HISTORIC AND DESIGN REVIEW COMMISSION

February 17, 2021

HDRC CASE NO: 2020-123
ADDRESS: 4674 S PRESA ST
LEGAL DESCRIPTION: NCB 7603 BLK 1 LOT S 124.2 FT OF 2 & SE 108.27 FT TRI OF 1
ZONING: C-2, RIO-5
CITY COUNCIL DIST.: 3
APPLICANT: David Ranjbar/Prime & Paradigm Construction, LLC.
OWNER: Shauaot Momin/SHAK & IKE CORPORATION
TYPE OF WORK: New construction
APPLICATION RECEIVED: January 25, 2021
60-DAY REVIEW: Not applicable due to City Council Emergency Orders
CASE MANAGER: Huy Pham
REQUEST:

The applicant is requesting a Certificate of Appropriateness for approval to construct 3,500 square-foot, one-story commercial structure at the lot on 4674 S Presa, on the west corner bounded by E Southcross to the north, S Presa to the west, and Stratford to the south.

SITE PLAN

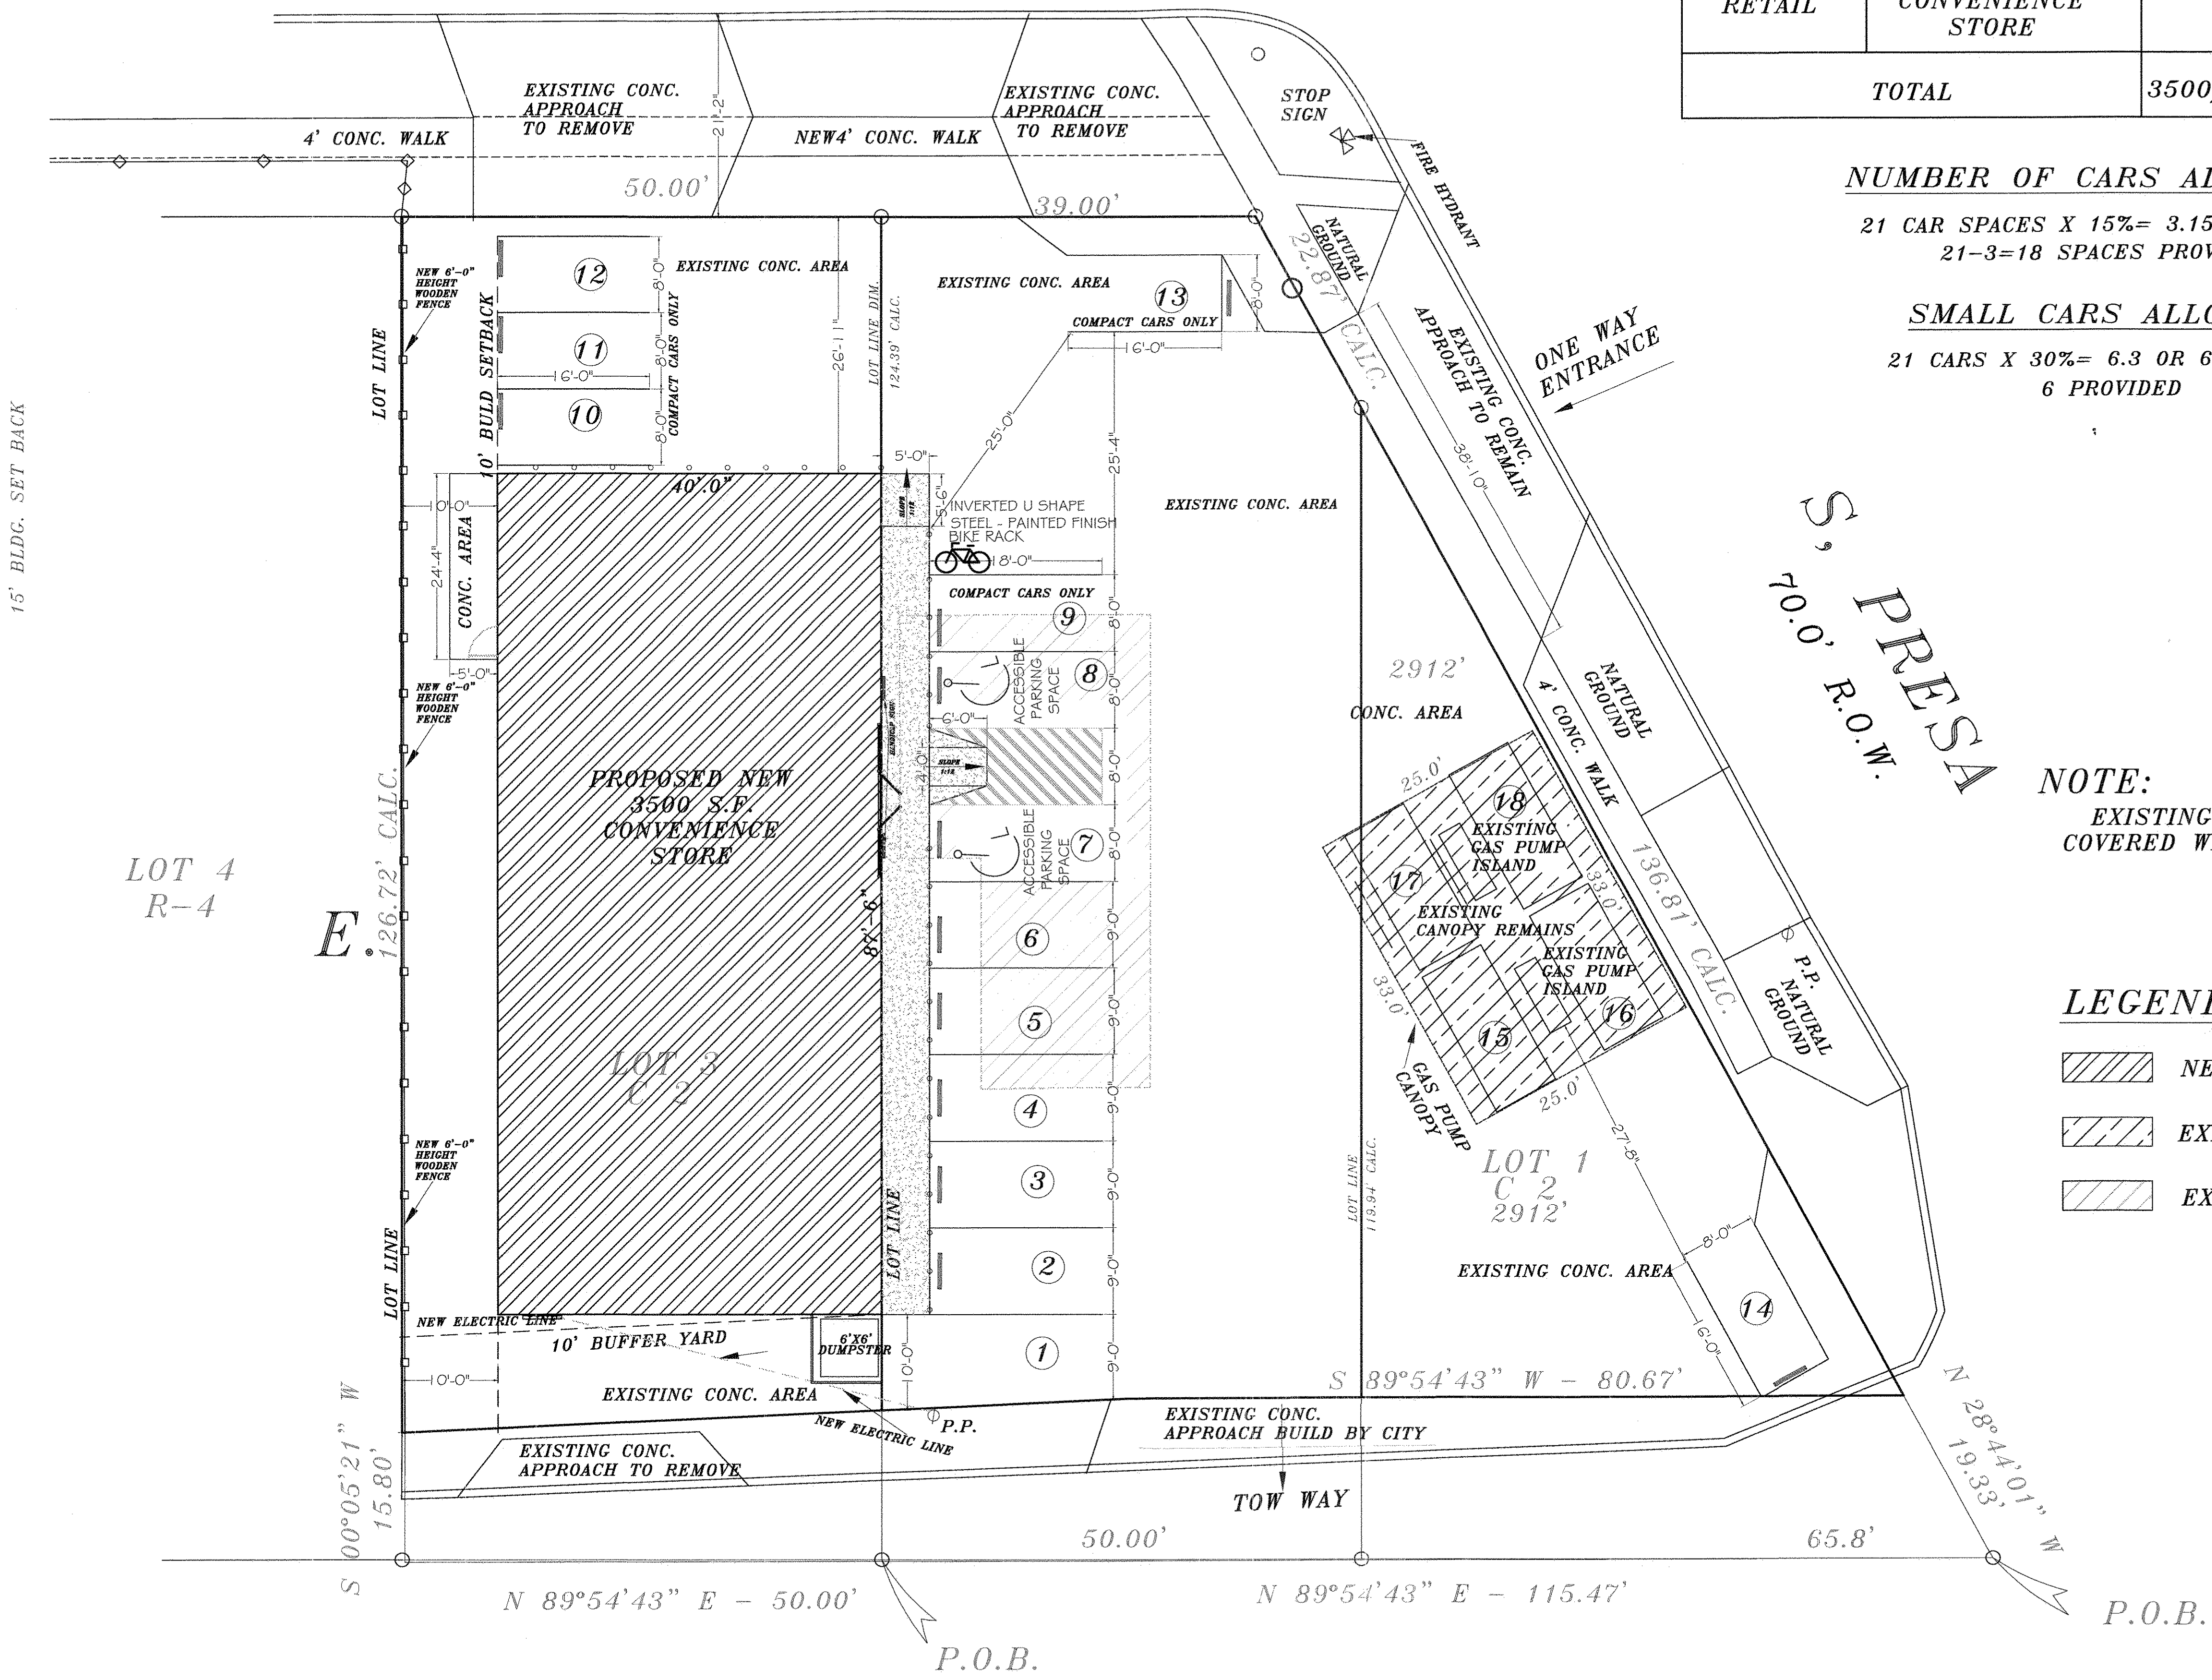
- e. PEDESTRIAN CIRCULATION – Per the UDC Section 35-672(a) in regards to pedestrian circulation, an applicant shall provide pedestrian access among properties to integrate neighborhoods. Per the applicant’s site plan, existing sidewalks will only be maintained along S Presa. Staff finds that sidewalks should be maintained around the perimeter of this corner property, on Stratford, S Presa, and E Southcross.

- h. **SITE DESIGN** – According to the UDC Section 35-673, buildings should be sited to help define active spaces for area users, provide pedestrian connections between sites, help animate the street scene and define street edges. Primary entrances should be oriented toward the street and shall be distinguishable by an architectural feature. The applicant has proposed a pedestrian entrance to front S Presa, consistent with the UDC.
